OBERHEIM ELECTRONICS, INC.
ENGINEERING CHANGE ORDER

402

OB-8

OB-8 POT. Board 1&2 1681A

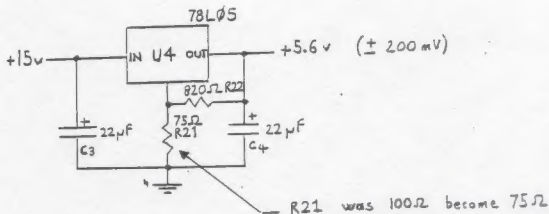
Reduce output of 5.6v Supply.

Increase the active range of the Front panel pots

OB-8 VOICE BOARD 1682 A

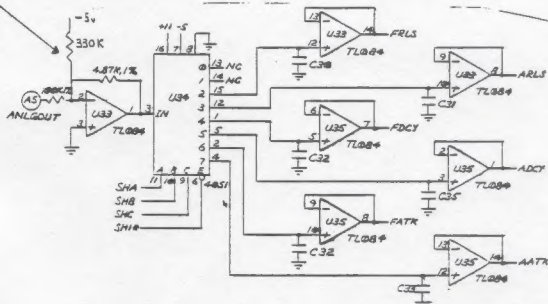
Add a resistor between -5v and pin 2 of U33 (upper & lower voice)
A software revision A-4 or posterior must be installed and the offset
calibration of the service center test must be performed.

The offset calibration routine of the service center test can correct
the TL084 for positive or negative offset.

OB-8 BEND BOX 1680A SHEET 1 OF 1

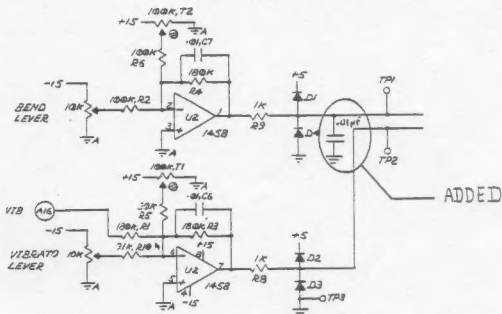
- REMOVES NOISE MODULATION FROM BENDER LEVER

PROCESSOR BOARD- POWER SUPPLY
1679A SHEET 4 of 4

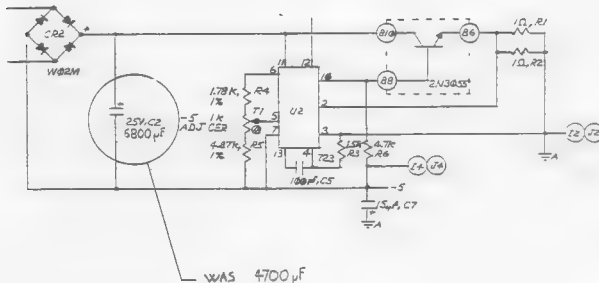
(REFERENCE ECO #401)

WHEN THE NEW POWER SUPPLY TRANSFORMER (REF.561021) IS USED, THIS CHANGE DECREASES THE OUTPUT THUMP ON POWER OFF.

1682A VOICE BOARD

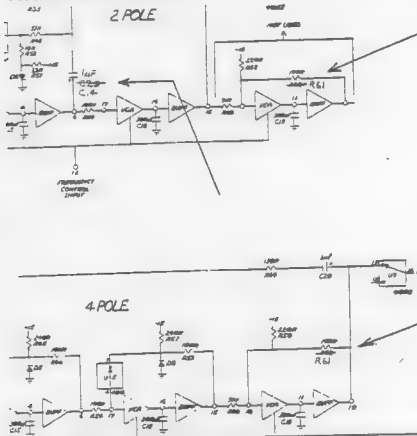
RESISTOR AT UX06 PINS 10, 18 MARKED RX68 SHOULD BE RX61.

CAPACITOR IN 2 POLE/4 POLE CONFIGURATION DRAWING MARKED C20 SHOULD BE C14.

OB-8 VOICE BOARD 1632 B SHEET 3 of 3

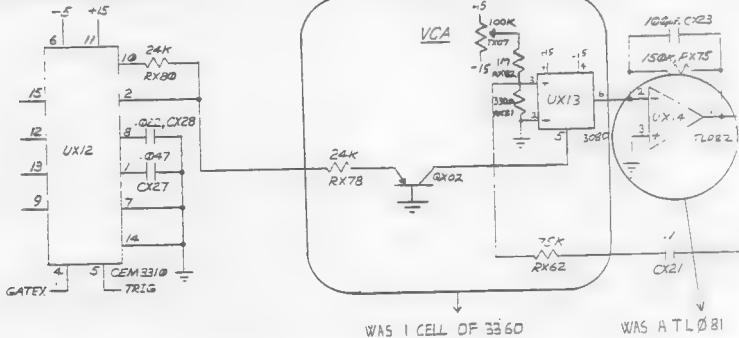
— ALSO: UX08 IS DELETED AND REPLACED BY THE OTHER CELL OF THE 74182 UX14

— RATIONALIZE THE CIRCUITRY

POT BOARD

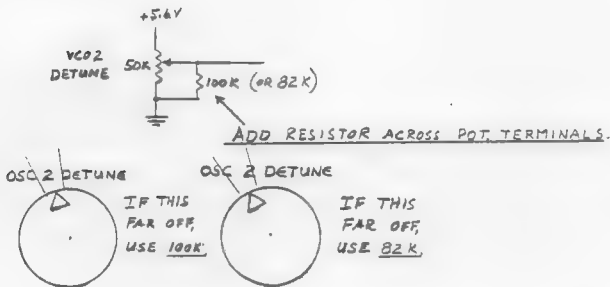
TO CENTER OSC 2 DETUNE CONTROL WHEN LED GOES OFF
WITH KNOB SIGNIFICANTLY COUNTERCLOCKWISE OF CENTER.

OB-8 VOICE BOARD 1682B SHEET 2

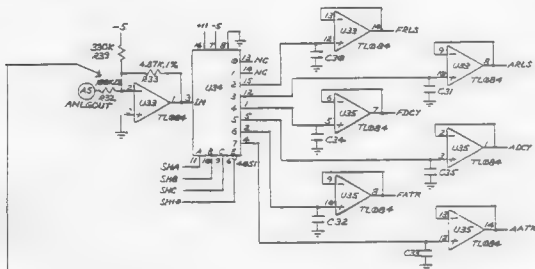
R32 100K 1% are 50 Ω matched between Lower and upper Tray.

R32 on the Lower and upper tray are mounted after the two boards are screwed together.

—IMPROVES MATCHING OF TIMING BETWEEN ENVELOPES OF UPPER AND LOWER TRAY.

1679 B - SHEET 1

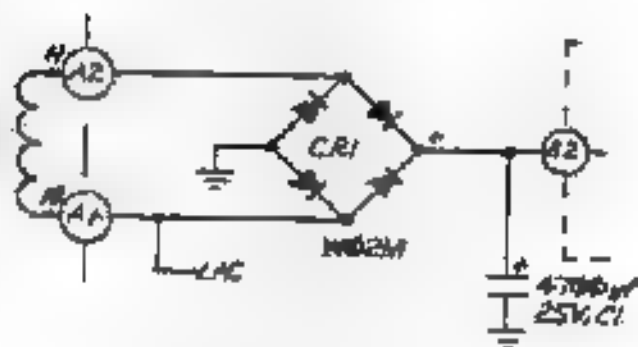
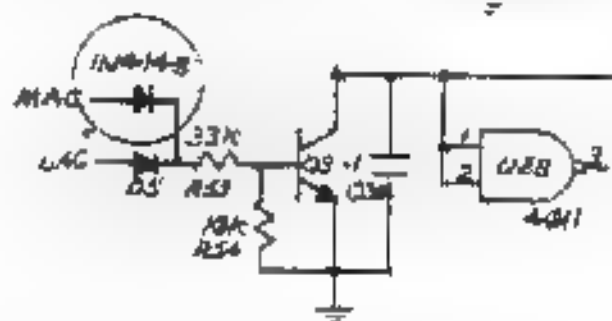
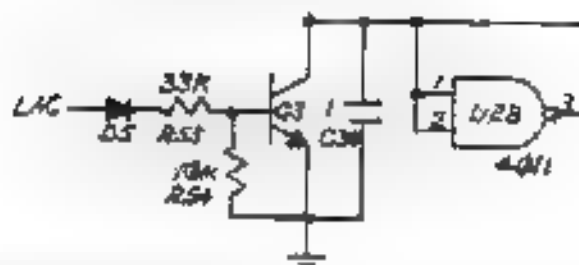
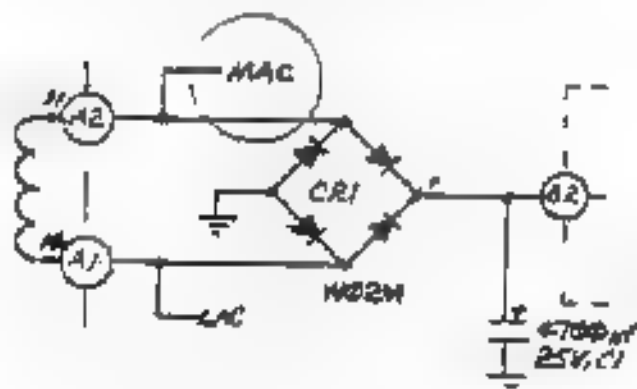
IMPROVE MARGIN OF "PVP" CIRCUIT TO INADVERTENT TURN-OFF, ESPECIALLY AT 50 Hz.

PROCESSOR BOARD 1679B SHEET 1 OF 4

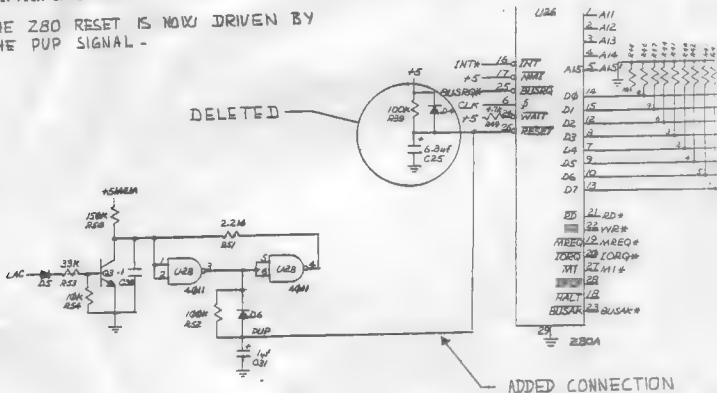
THE Z80 RESET IS NOW DRIVEN BY
THE PUP SIGNAL -

TO AVOID POSSIBLE MEMORY DROP CAUSED BY SHORT POWER DROP

POWER SUPPLY

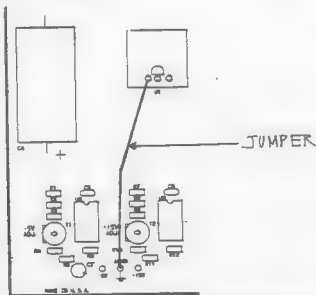
ADD A JUMPER BETWEEN PIN 1 OF THE -15 REGULATOR
7915 (GND) AND THE GROUND REFERENCE TEST POINT.
THE JUMPER MUST BE MADE OF A 18 AWG WIRE (.04 inch / 1 mm)
MINIMUM AND MUST BE SHORT.

TO REMOVE AC HUM ON AUDIO OUTPUT.

DRAWINGS AFFECTED
08-8 MOD CAN SCHEMATIC
SHEET 1 OF 1.

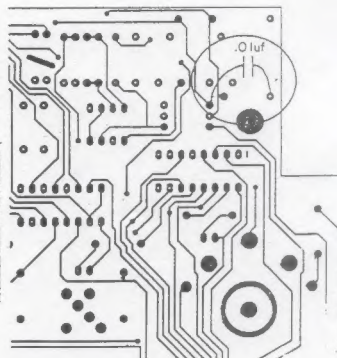
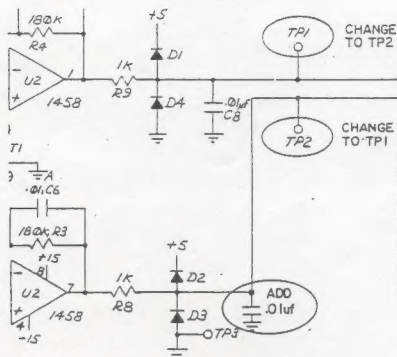
REMOVE NOISE MODULATION FROM
VIBRATO LEVER, AND CORRECT
SCHEMATIC.

1. CHANGE SCHEMATIC AS SHOWN.
2. ADD .01uF CAP (OB.153004) FROM GROUND TO TEST POINT (T.P. 2) OF MOD CAN PCB ON 1666 SIDE OF BOARD.

DRAWINGS AFFECTED VOICE BOARD
SCHEMATIC 1682B SHEET 3 OF 3

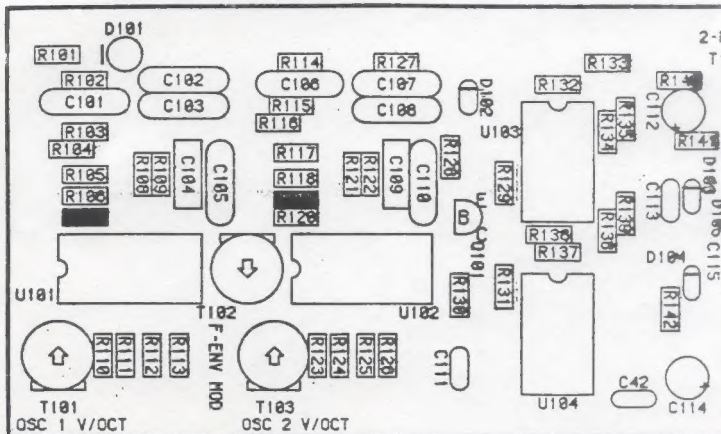
LOWER INITIAL FREQUENCY OF 3340
TO ACCOMMODATE A WIDER RANGE
OF CHARACTERISTIC VARIATIONS ON
THE 3340.

REPLACE RESISTOR RX07 AND RX19 (215K, 1%)
WITH 174K, 1% (OB#475520).

OB-8 VOICE BOARD 1682 A SHEET 30F2

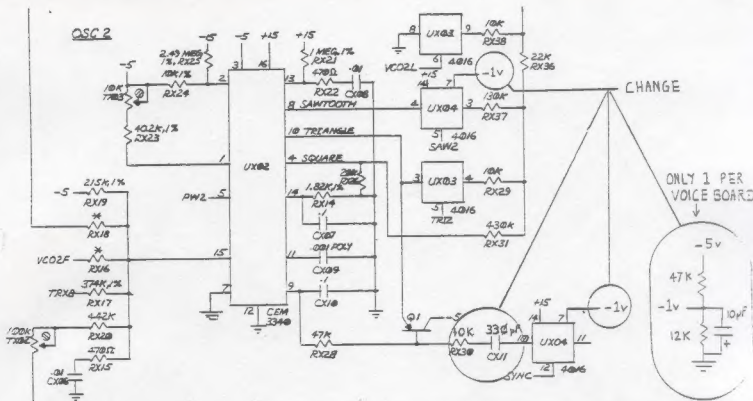
- IMPROVES SYNCHRO SOUND
